Our Reference: G36809L-02A

10 Eighth Street, Eildon – Proposed Key Worker Housing Subdivision Traffic Engineering Assessment

We have been engaged to undertake a traffic engineering assessment of the proposed residential subdivision (key worker housing) located at 10 Eighth Street, Eildon.

Figure 2: Egress for Lot 7

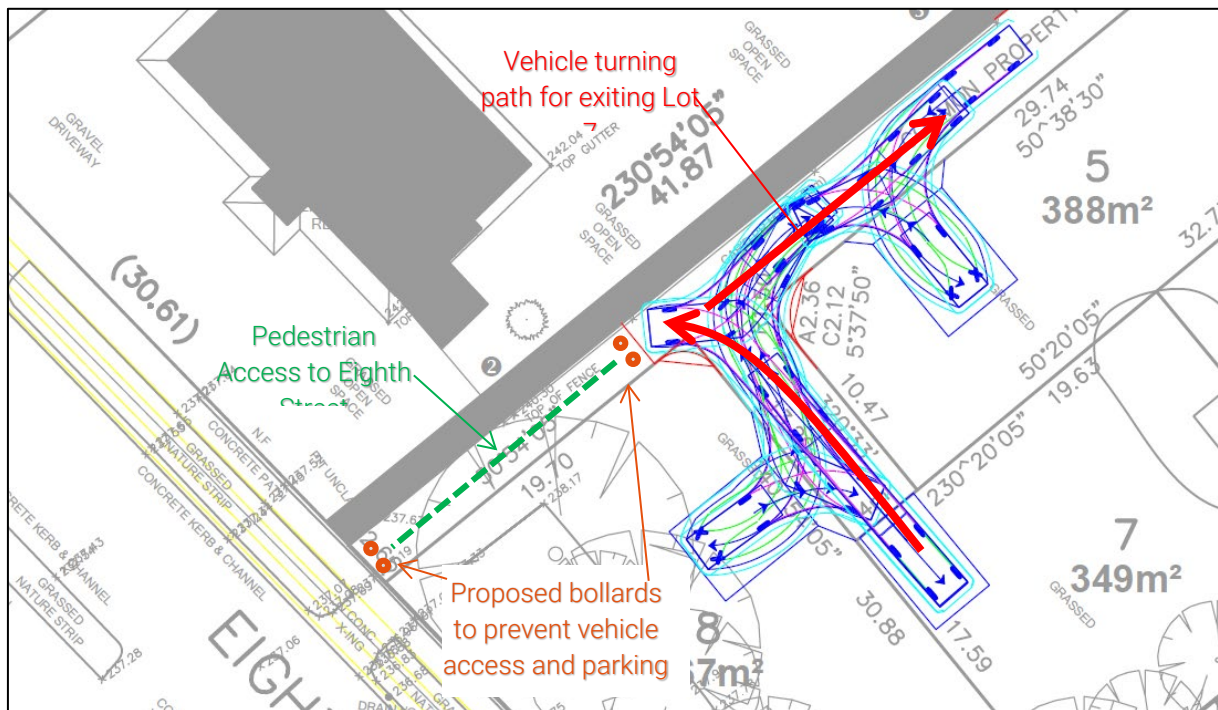
Vehicles exiting Lot 7 can reverse and turn around in the pedestrian walkway area adjacent to Lot 8. It is recommended that bollards be included as shown in Figure 2 below to prevent vehicles parking in the area allocated for Lot 7 turnaround and also to prevent vehicles driving along the pedestrian walkway and exiting to Eighth Street.

Figure 3: Indicative Common Property Area to Provide Access to Lots 4 and 6

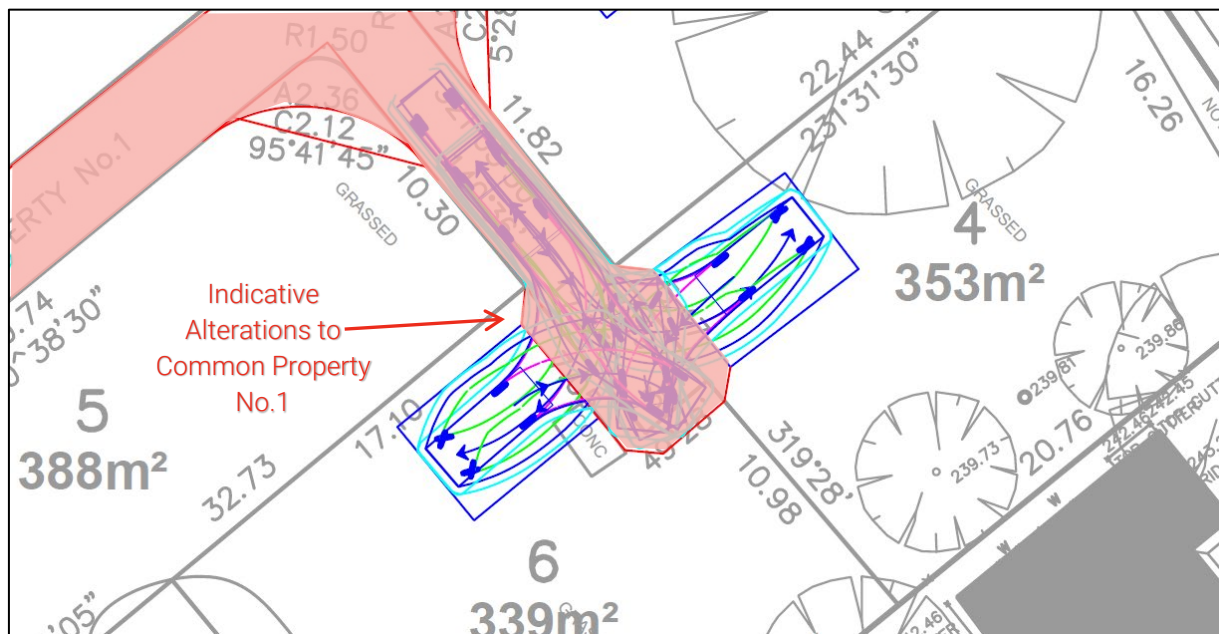
Swept path diagrams indicate that the lot boundaries for Lots 4 and 6 will need to be set back to provide a "courtbow" type arrangement to allow for vehicles to exit each of these lots without encroaching onto another lot and exit the site in a forwards direction as required by Design Standard 1 of Clause 52.06-9.

The mark-up at Figure 3 below shows the area required to be allocated as part of Common Property 1 to provide adequate manoeuvring space for Lots 4 and 6.

Subdivision Plans

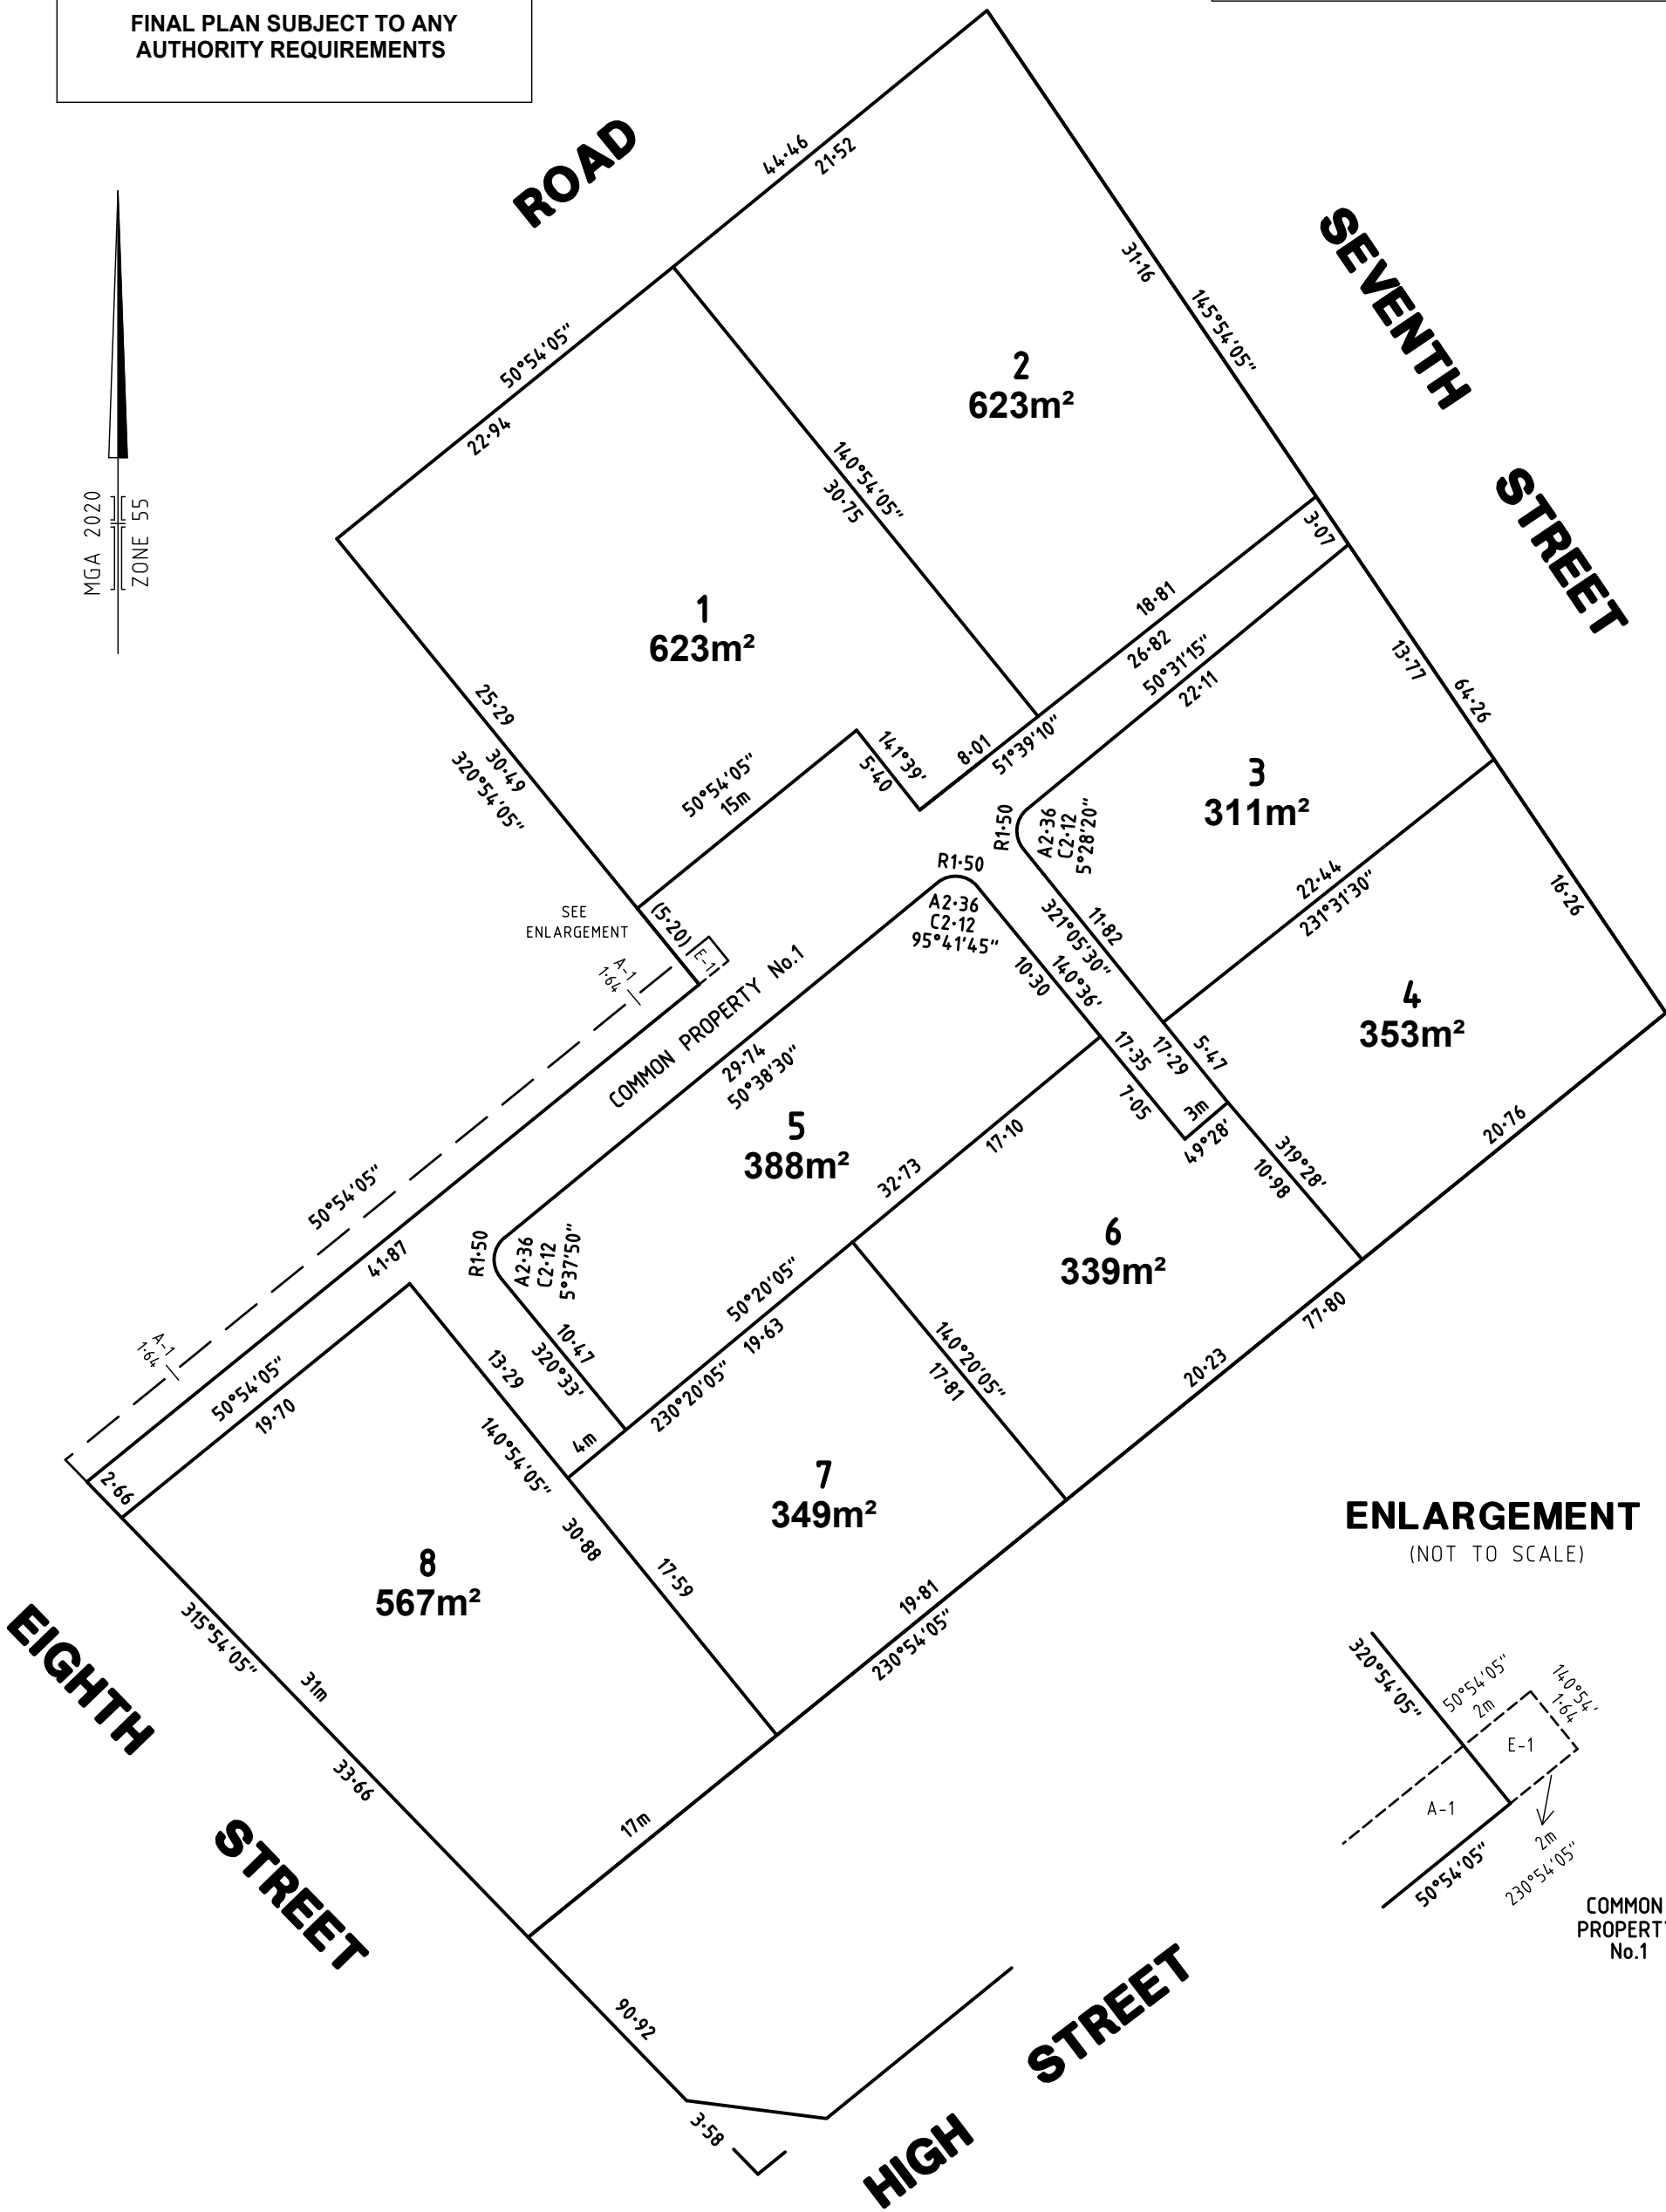
The subdivision plan shows an indicative 5.4m x 15m area in front of Lot 1 set aside for the purpose of visitor parking. It is noted that while this area could provide for visitor parking, the

width of the common property access aisle does not comply with the minimum access aisle requirements for 90-degree visitor parking.

The indicative mark-up attached at Appendix B shows how two visitor parking spaces could be provided closer to the site entrance, making use of the wider two-way access aisle section. In that case, the 15m x 5.4m section in front of Lot 1 could be incorporated into Lot 1.

For a 6.1m access aisle, Design Standard 2 of Clause 52.06-9 requires that visitor spaces be 4.9m long and 2.8m wide, as shown on the attached mark-up.
